Union County, Georgia

ADDENDUM # 1
February 24, 2025
Union County New 911 Center Facility Construction
Project# UC-2025-01

This addendum is issued to change or clarify the proposal documents associated with the Union County RFP for Union County New 911 Center Facility Construction Issued January 29, 2025

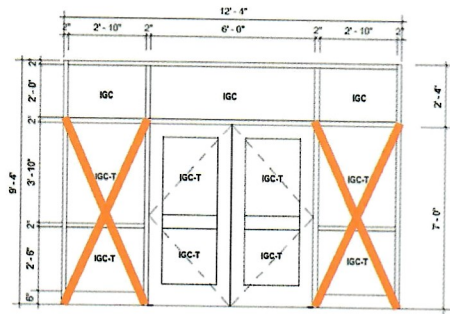
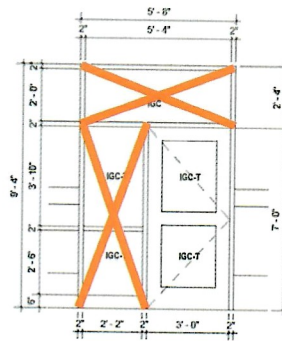
Question 17:

Please confirm location of window blinds at exterior windows. Should the transom also receive blinds? See illustration below showing two options. The X marks location of blinds.

SF4

SF5

Window blinds shall also be furnished at transoms above doors / windows.
